**TO:** Mills City Council  
**FROM:** Megan Nelms, AICP, City Planner  
**DATE:** January 8, 2024  
**SUBJECT:** **257 Business Park** – Preliminary Plat

**Case Number:** 23.08 FSP

## 257 Business Park

### Preliminary Plat

# PRELIMINARY PLAT OF 257 BUSINESS PARK

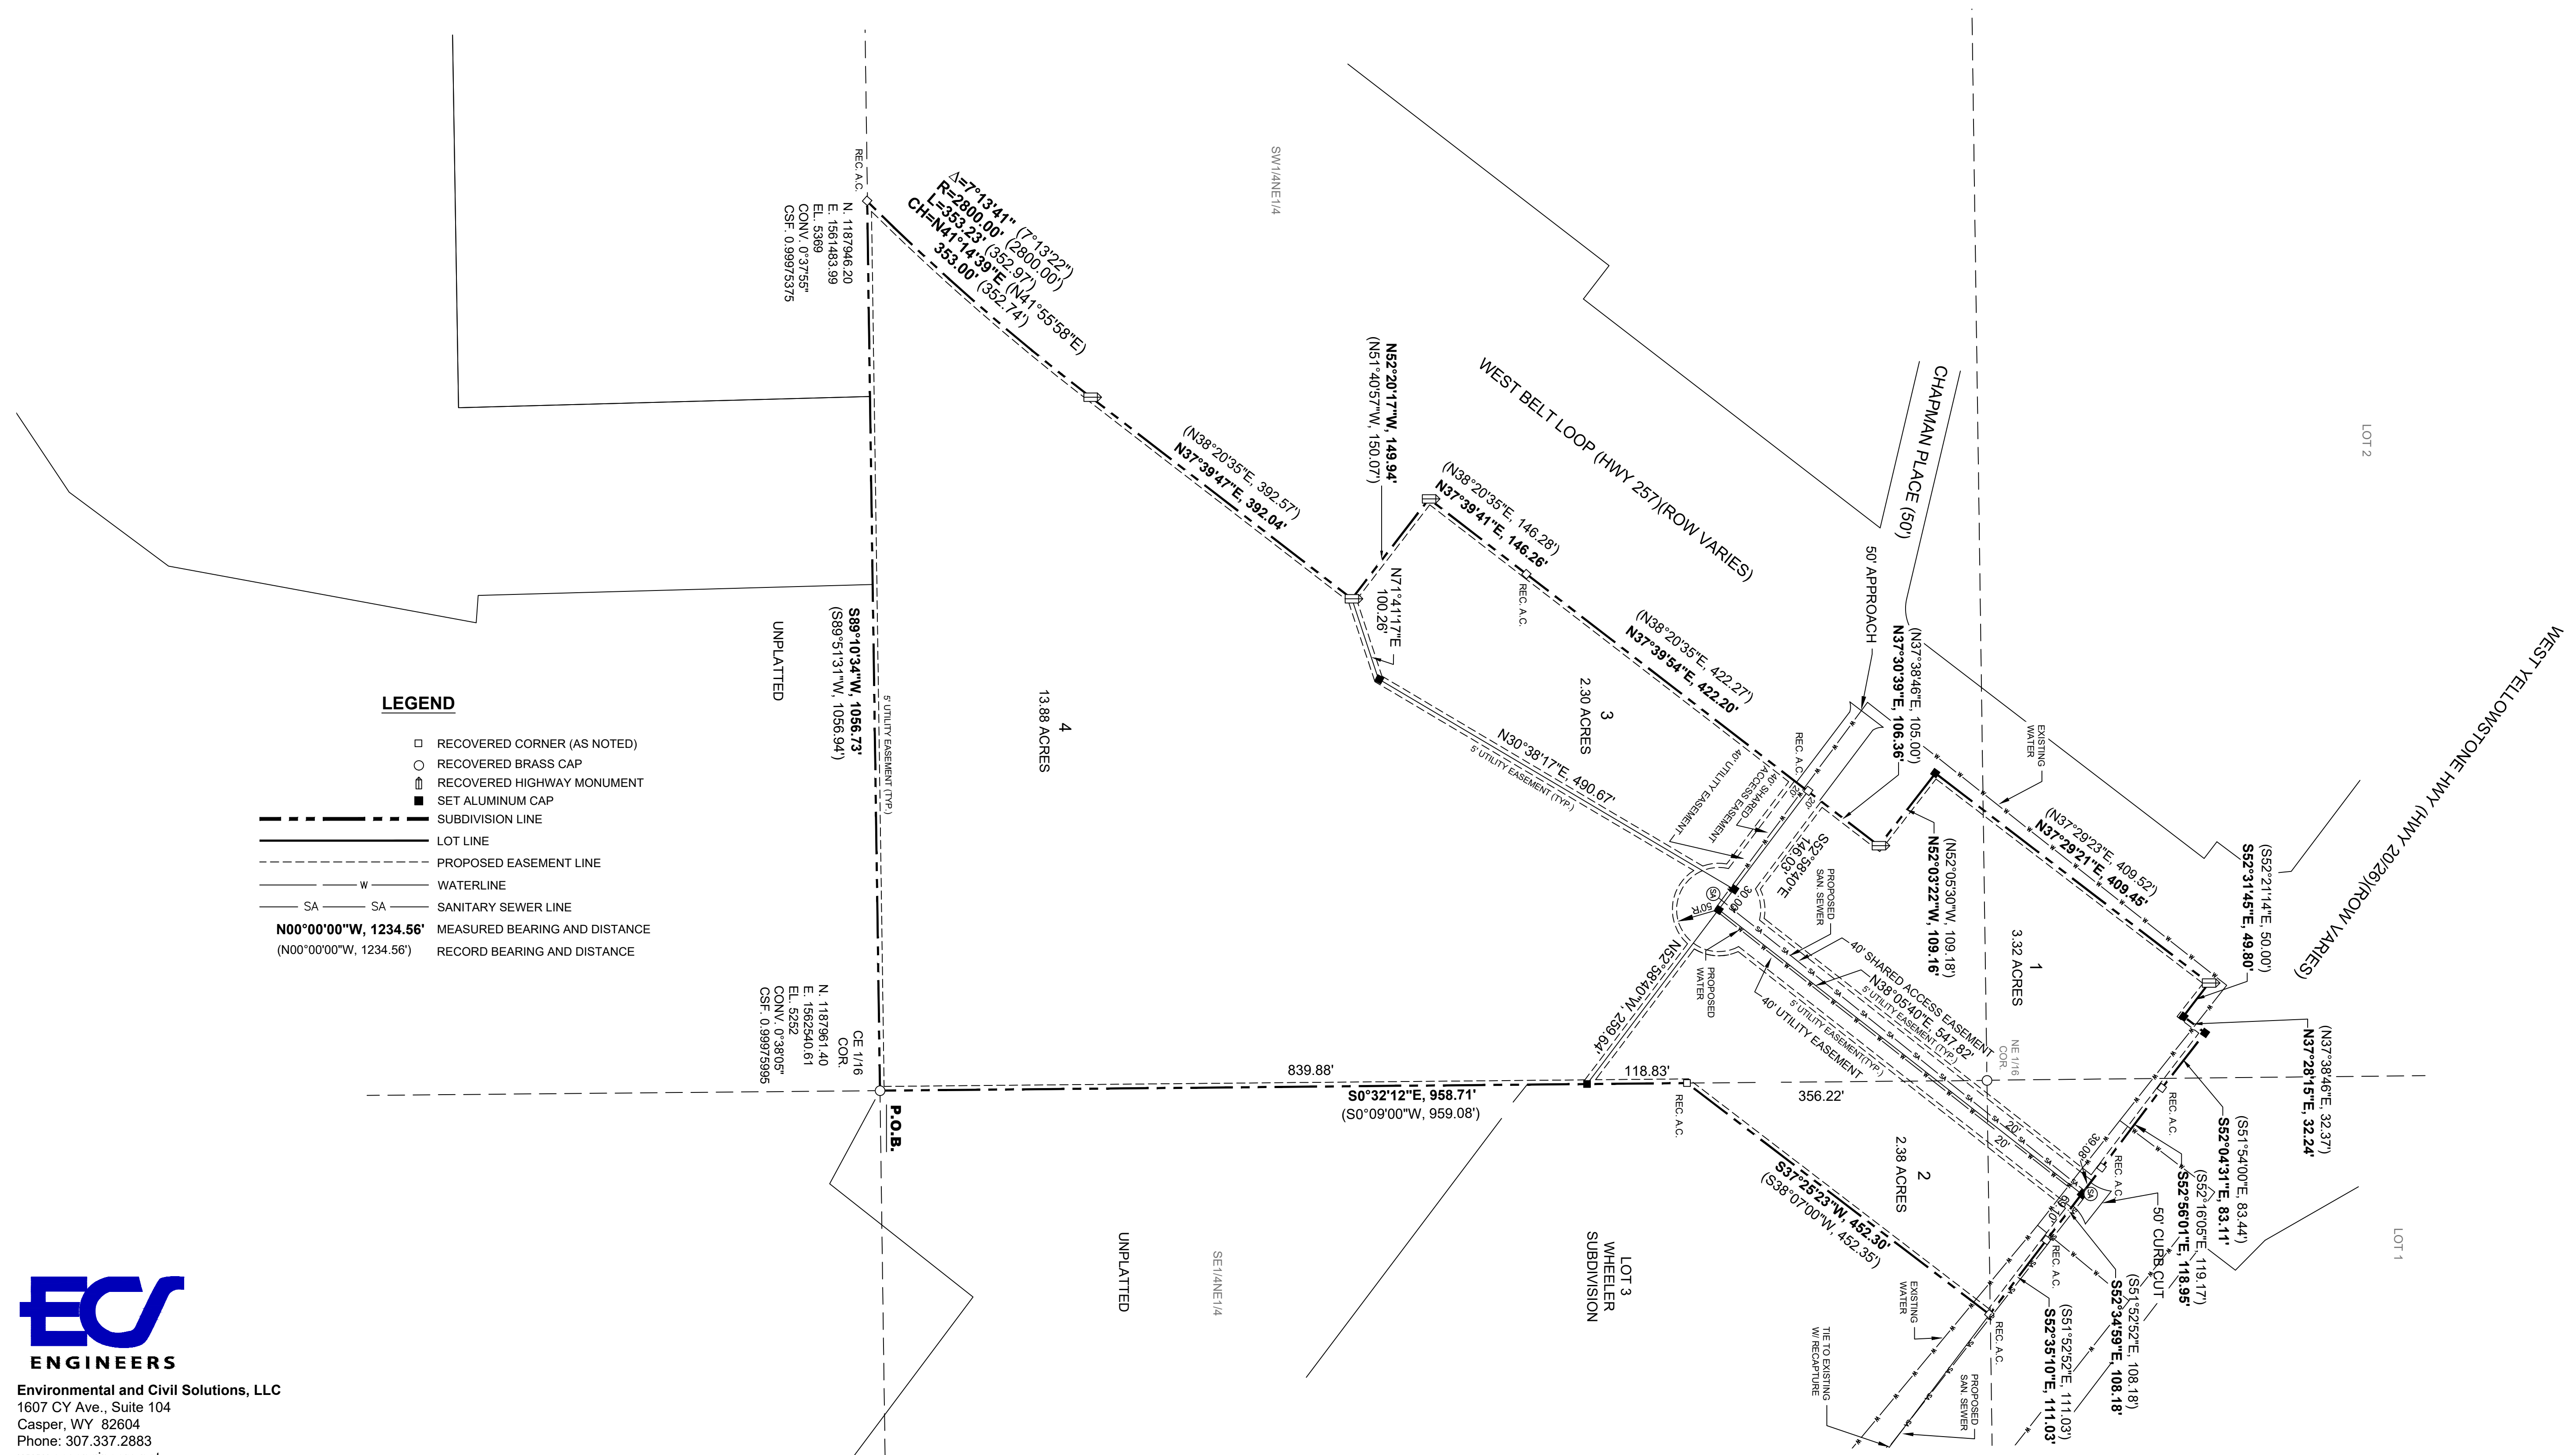
- Infrastructure Improvements (Chapter 16.16).
- b. Per 16.16.060, the minimum right-of-way/access easement width for a local street within low density development is 50’.

3. Add road names to all streets within the subdivision
    - a. The access between Lots 1 & 3 should be named Chapman
    - b. Provide a name for the access between Lots 1 & 2

6. All cul-de-sacs shall have a diameter of no less than 96’.
  7. Delineate the drainage easement on one of the lots, instead of showing it as its own parcel.

8. Survey Review:
    - a. Add State Plane Coordinates, northing, easting, elevation, Convergence and Combined Factor to two (2) of the exterior corners.

- b. The coordinates are in grid but the distances are in ground
    - c. Verify the north corner(s) of the plat and Lot 1. Review Instrument #866007 as excepted in Instrument #1143765, with regard to the WYDOT parcel.

- d. There is a mis-closure of Lot 4 by 1.63 feet
  9. Cosmetic Revisions to the Plat:
    - a. Add TO THE CITY OF MILLS under “Plat of 257 Business Park” in the title block on both plat sheets.

- b. Make the adjacent subdivision and road names gray.
-
